Appn No. : 10/002,763

**RESPONSE TO OFFICE ACTION OF 11/16/04  
REMARKS AND ARGUMENTS**

FIG. 1

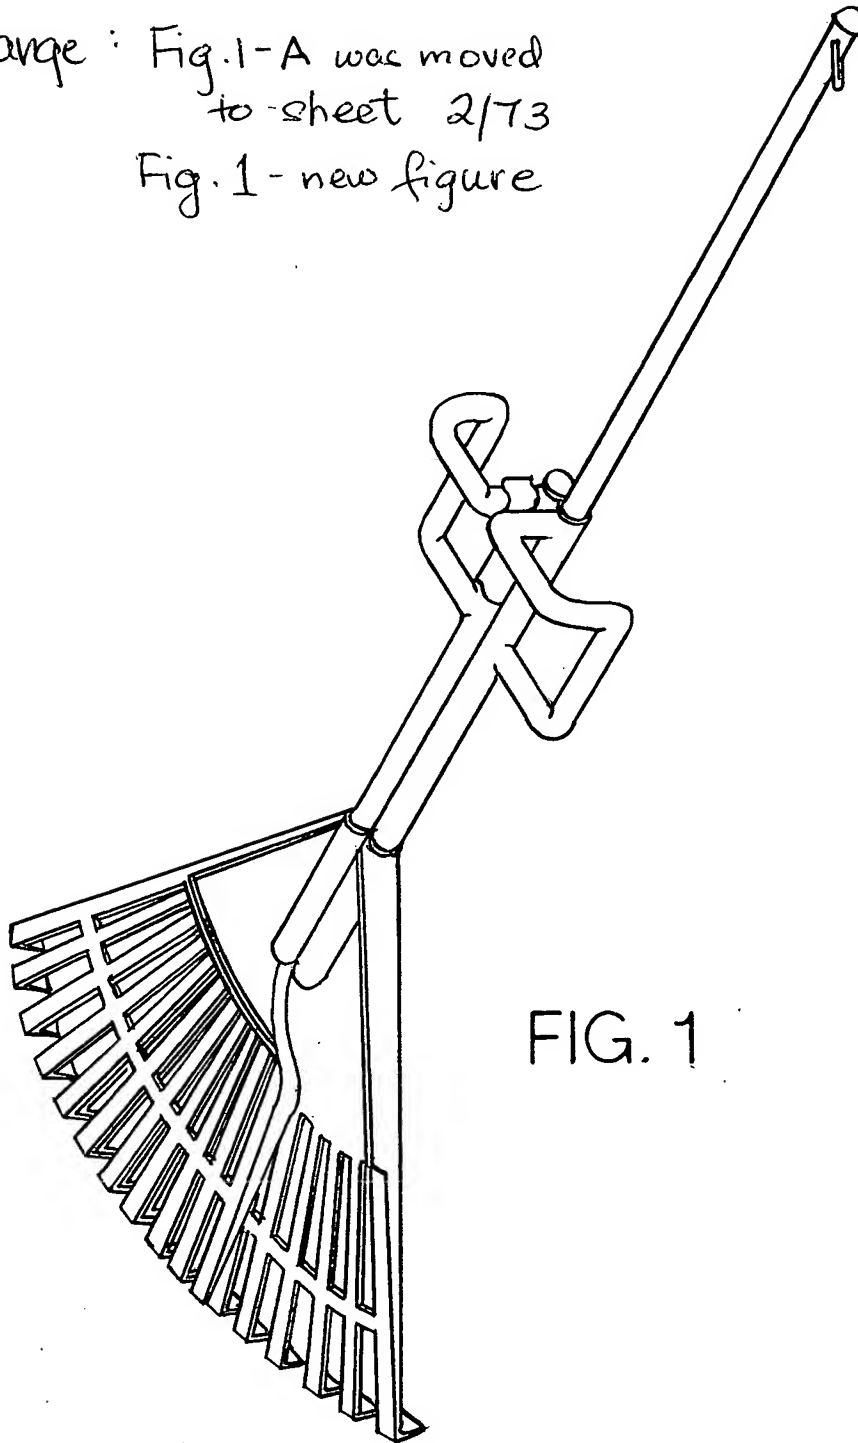
change : Fig.1-A was moved  
to sheet 2/73  
Fig.1 - new figure

Fig.1 depicting the elected embodiment is provided as sheet #1. This figure will precede Fig. 1-A in the order of presentation. Since Figs. 1-A and 1-A' are made to fit in one sheet(sheet#2) instead of two, the total number of sheets is maintained. This will minimize the need to re-number the rest of the drawing sheets. The Description of Drawings section of the application has been amended accordingly.

2/73

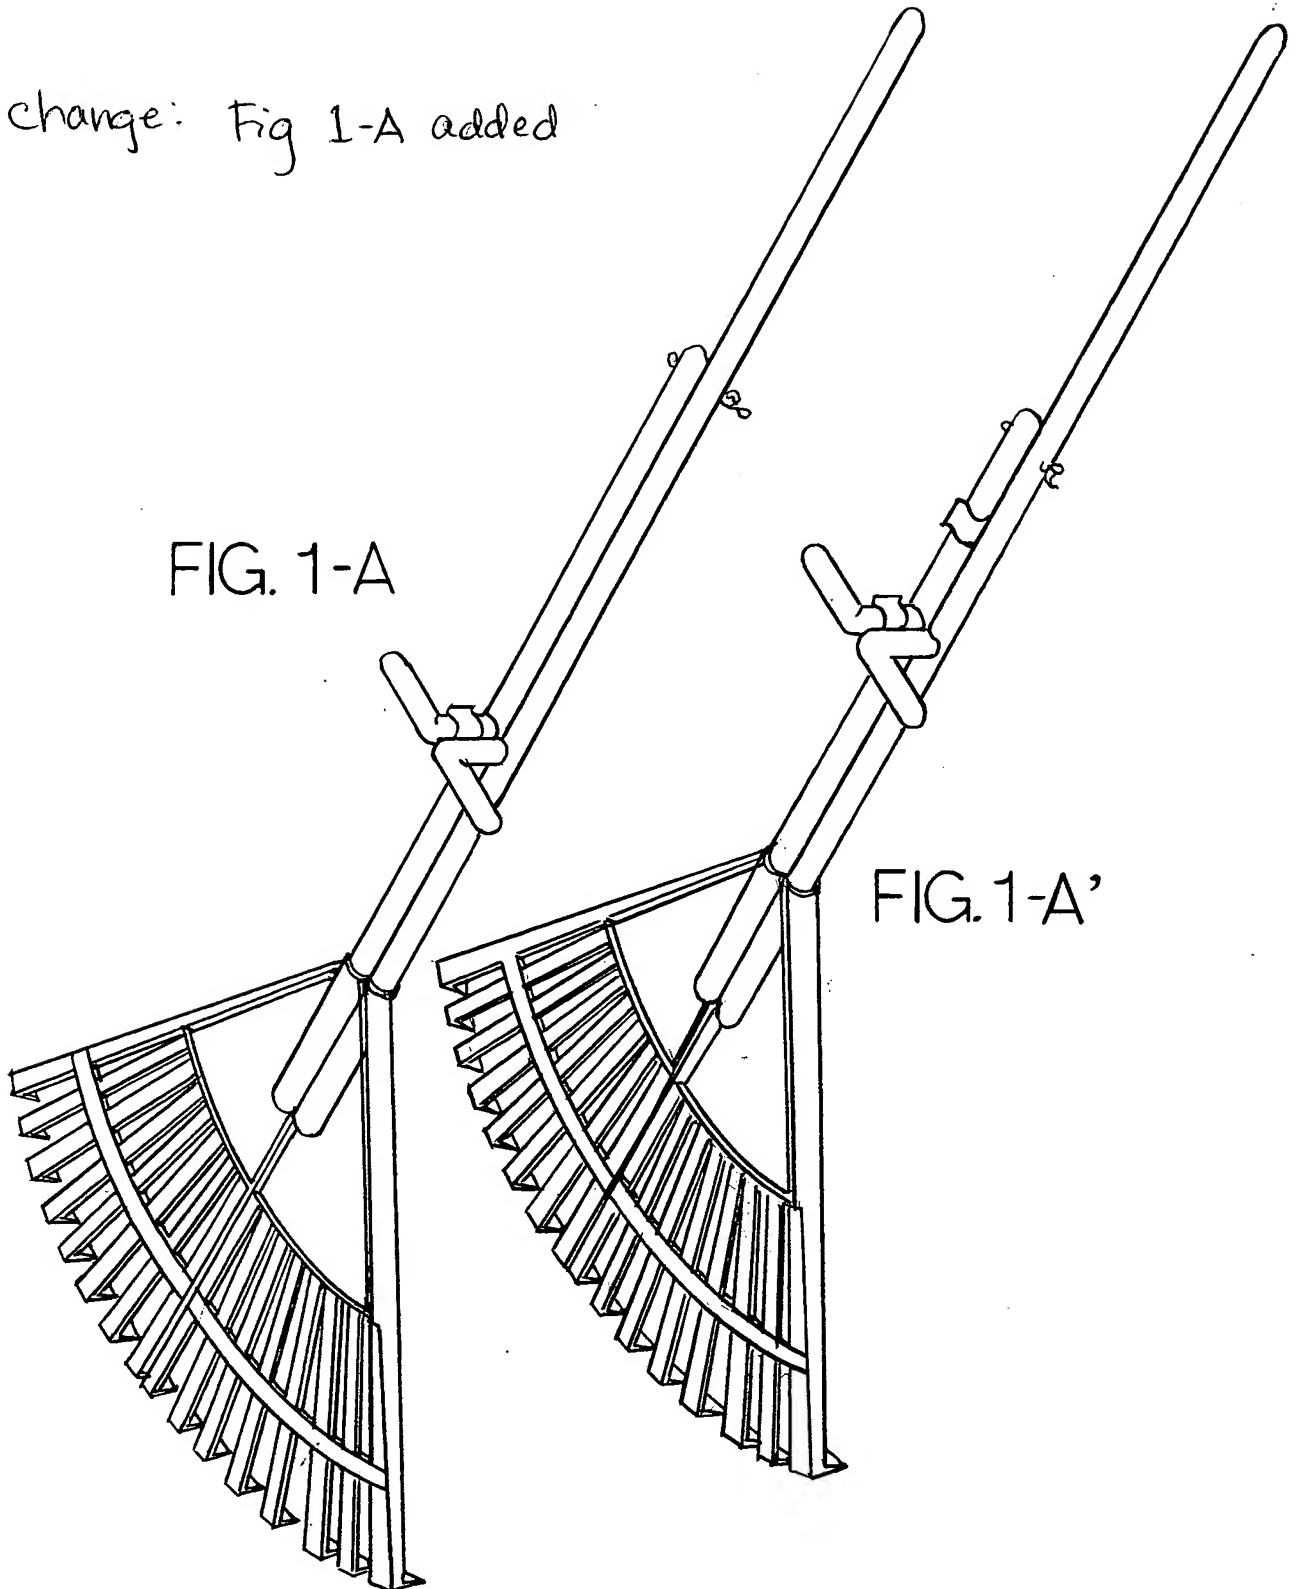
change: Fig 1-A added

FIG. 1-B

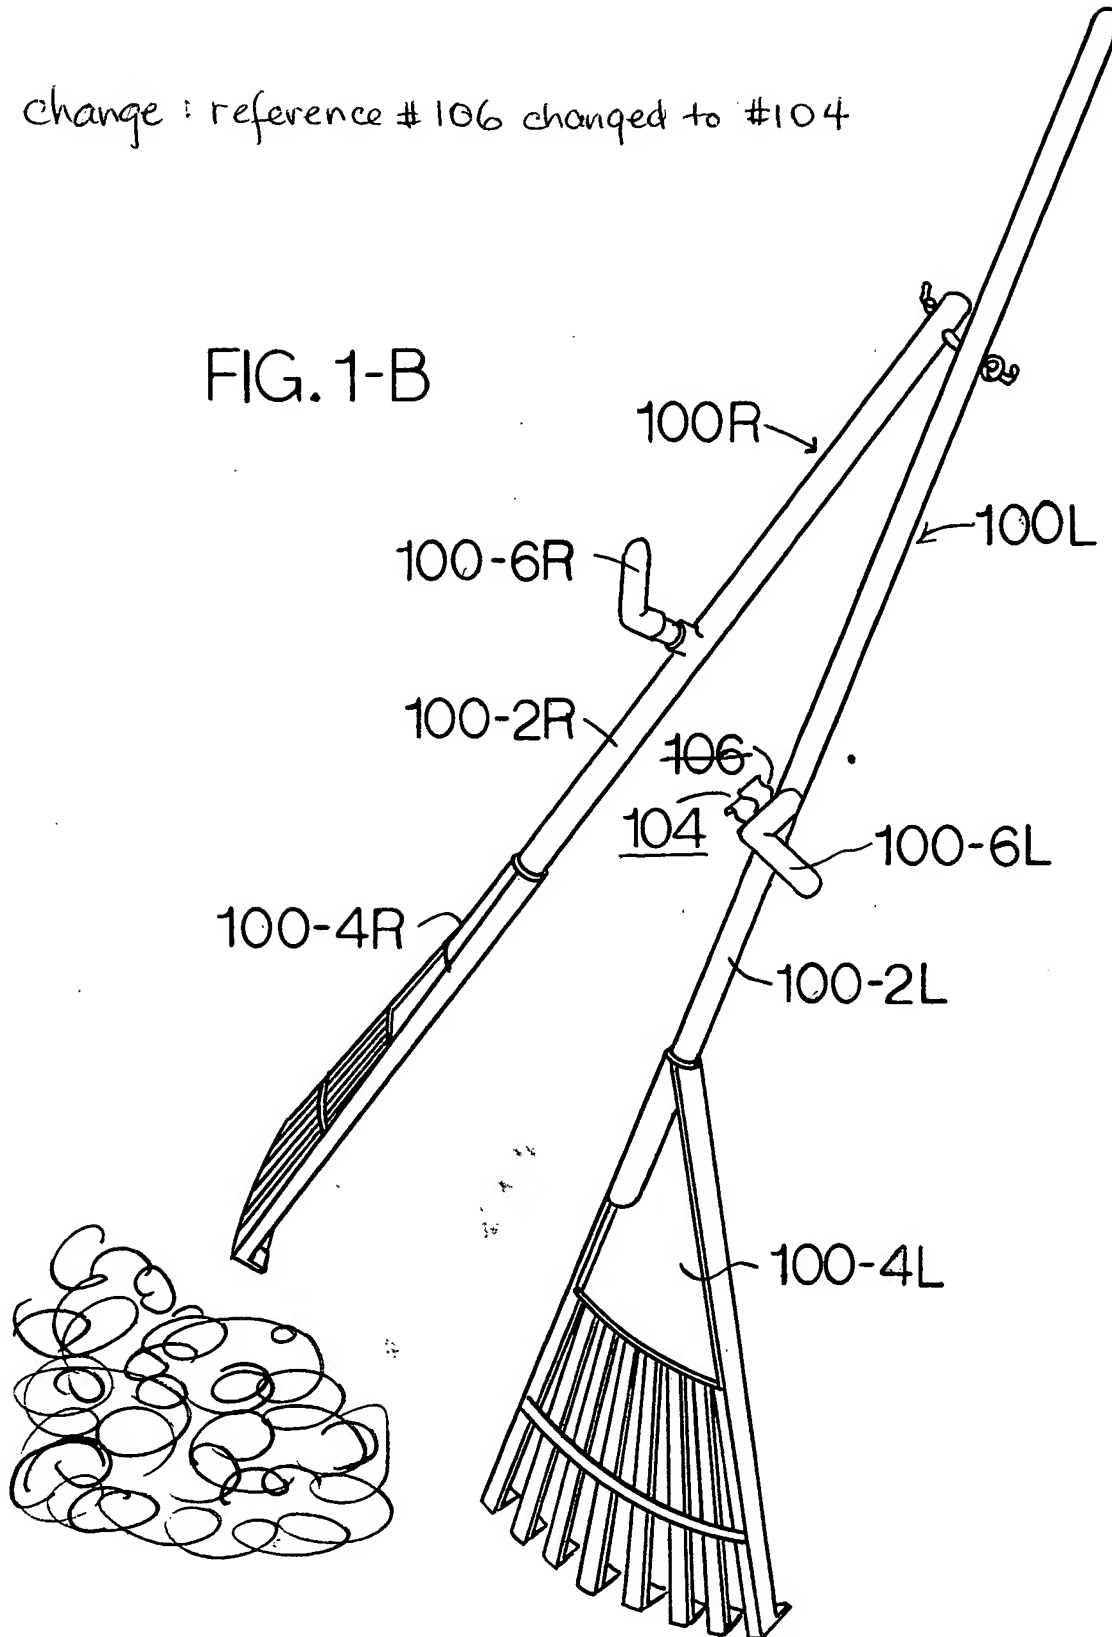
change : reference # 106 changed to #104

In addition, the applicant finds it appropriate to amend Fig. 1-B (sheet#3) and Fig. 1-C (Sheet#4). The reference number for the gripper on the vertical portion of the transverse branch will be changed from #106 to #104. This change is done in order to establish consistency between Fig. 1-B and Fig. 6-CL. In Fig. 6-CL the gripper on the vertical portion of the transverse branch is ref. #104 while the gripper on the elongated member proximal the branches is ref. #106. It is hoped that the resulting consistency will better help the reader see the connection between the embodiment in Fig. 1-A and that in Fig. 6-A, how the former could easily "metamorphose" into the latter. Corresponding amendments to the specification section is also submitted in the Specification Amendments section of this Response. No new material is added.

FIG. 1-C

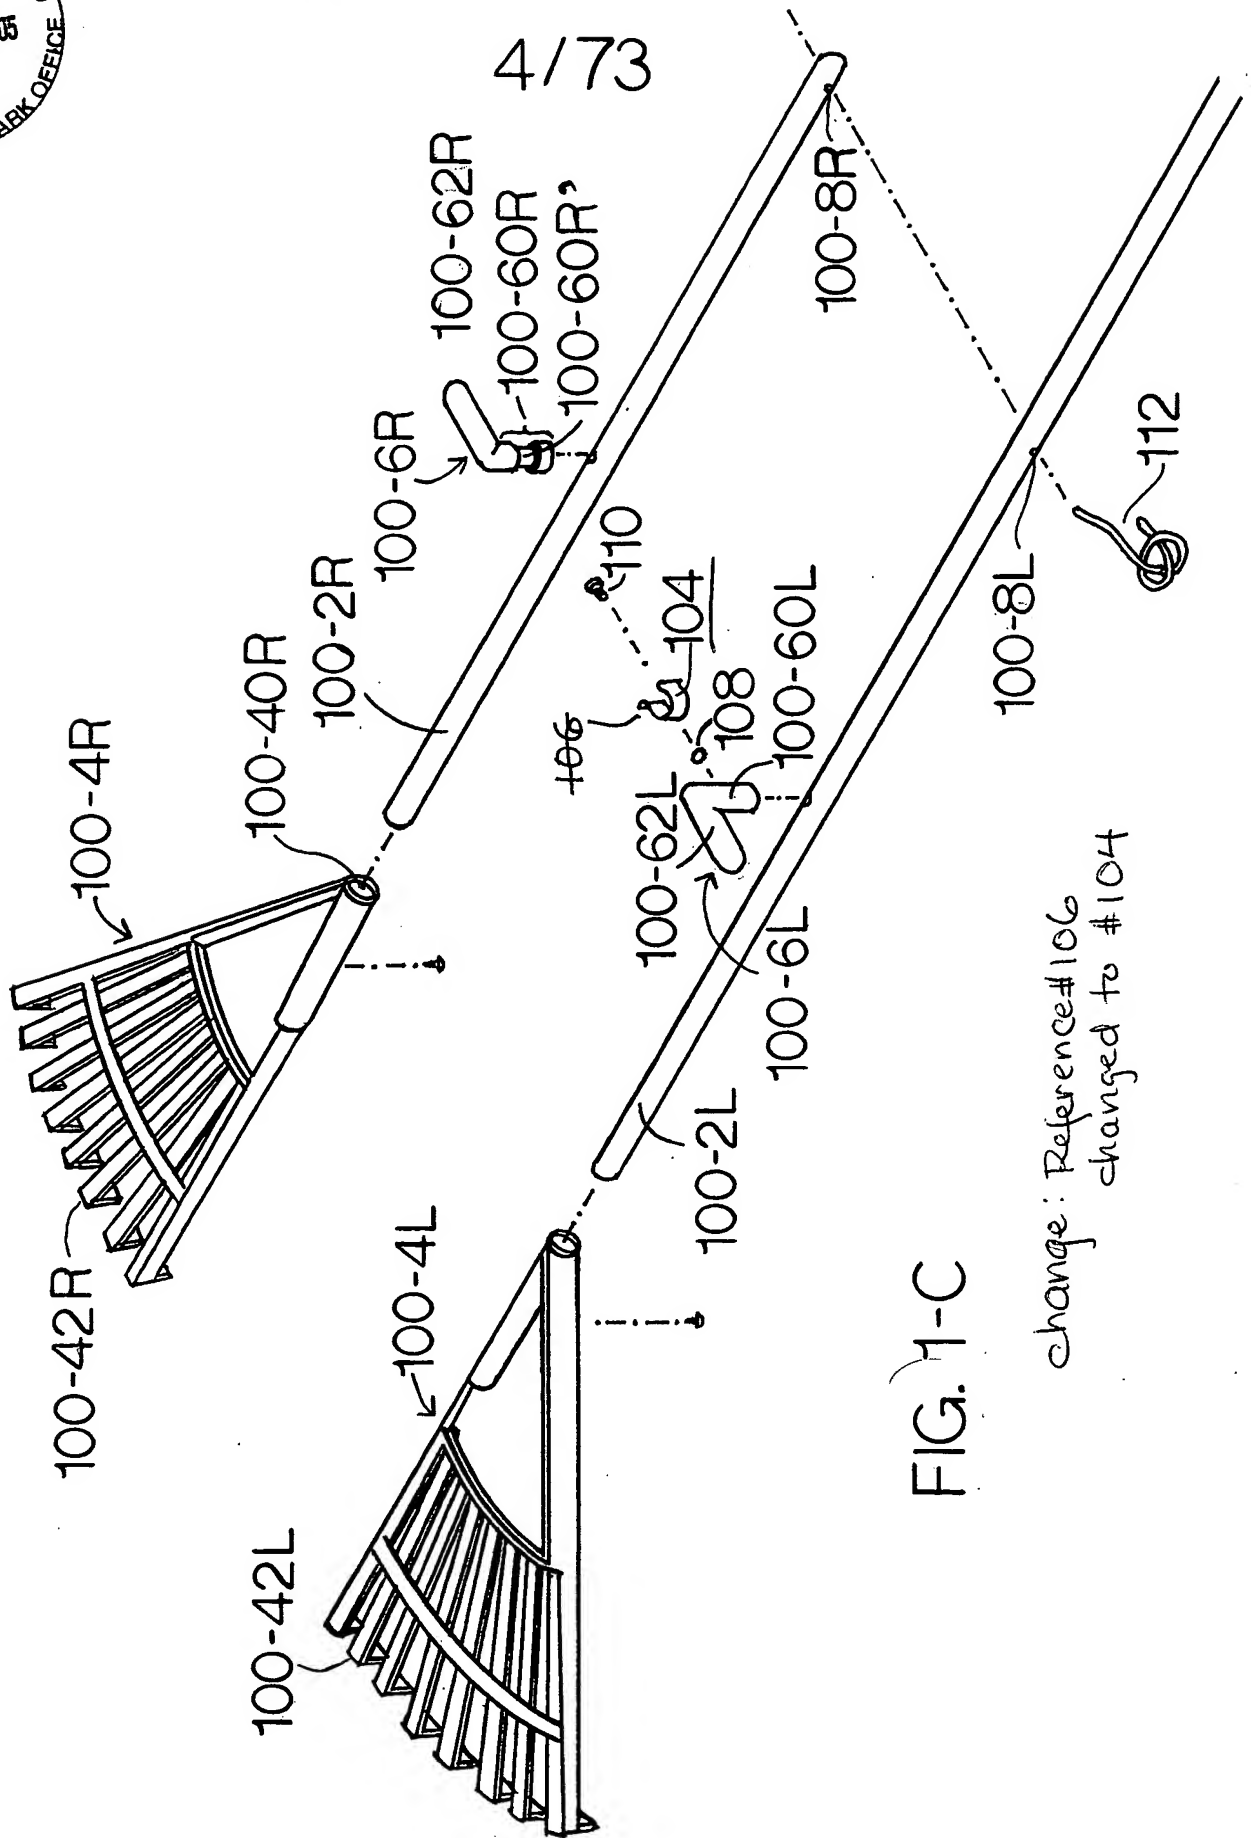
change: Reference #106  
 changed to #104

20/73<sup>+</sup>

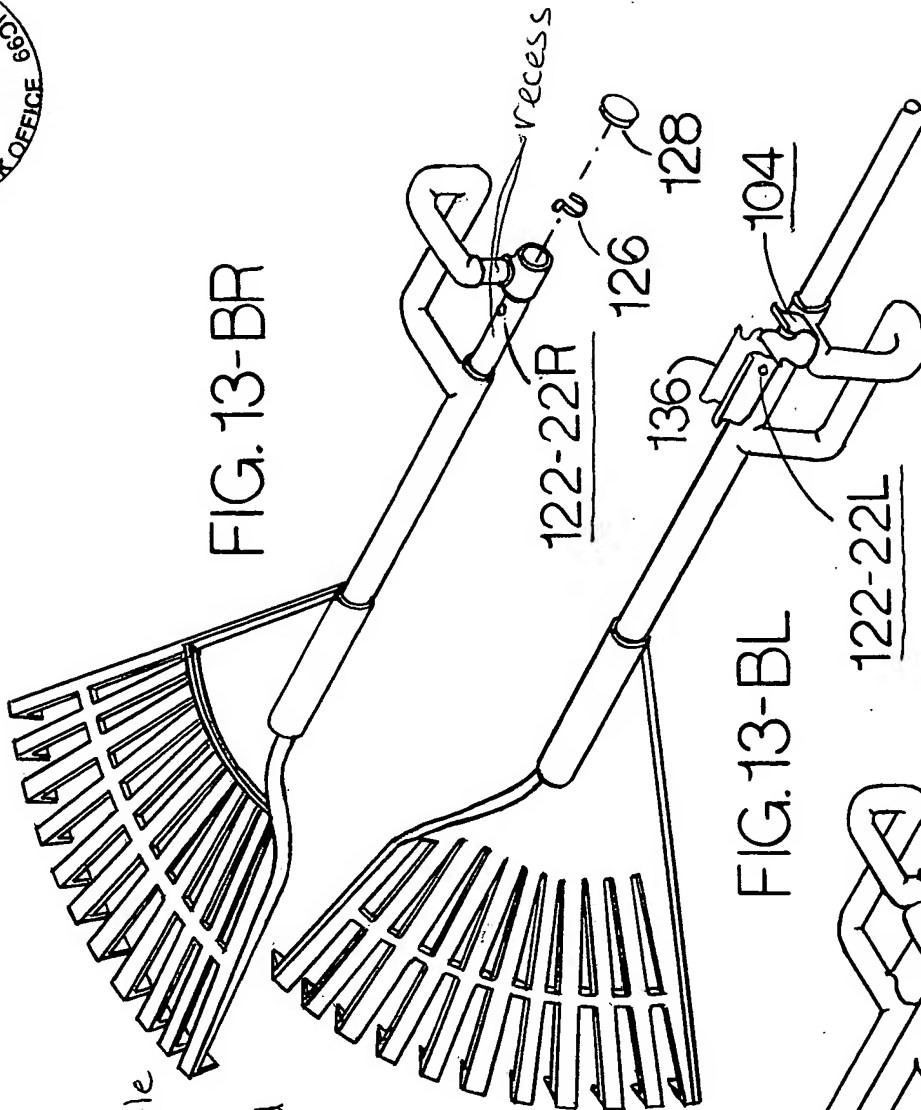
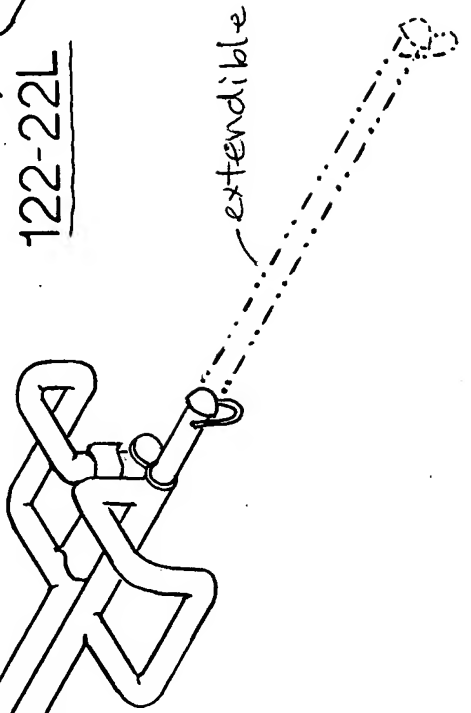
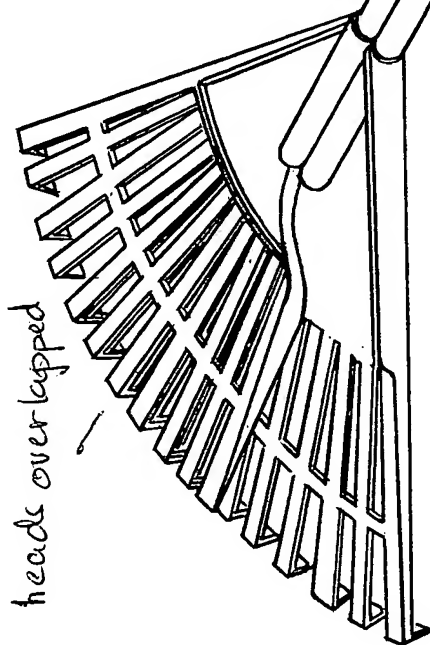
**1. Drawing Objections:** The drawings are objected to under 37 CFR 1.83(a) because the drawings of the specie of Figs.13-A, 13-BL, and 13-BR do not show every feature of the invention specified in the claims, specifically the following:

- change perspective view
- rake heads overlapped
  - handle shown as extendible
  - apertures 122-22L and 122-22R are shown
  - recesses are emphasized
  - 2nd gripper 104 added

heads overlapped

**Figs.13-A, 13-BL, and 13-BR (sheet # 20) are amended to better illustrate the claimed embodiment of the present invention.** No new matter is added. All of elements (a) to (e) above are amply discussed in the specifications and illustrated in the drawings (although not all of them are together in one figure).

Nevertheless, the applicant is trying very hard to comply with the Examiner's requirements if only to have some dependent claims treated on their merit and consequently allowed. The rake heads are overlapped, a second gripper is added, the recessed section is emphasized, the handle is shown as extendible, and the perspective views are revised to show the second aperture. No new matter is added.

The revised perspective views in Figs.13-BL and 13-BR now show the first and second apertures and snap button. No new matter is added.

Fig. 1 and revised Figs.13-A, 13-BL, and 13-BR now show the left rake handle as being extendible. No new matter is added. The details of the extendible handle are discussed under subsection headings Adjustable Handle Length, Version II and More detailed Discussion of Some Means of Telescoping Tubes. These are further supported in Figs.36-A through 43-C.
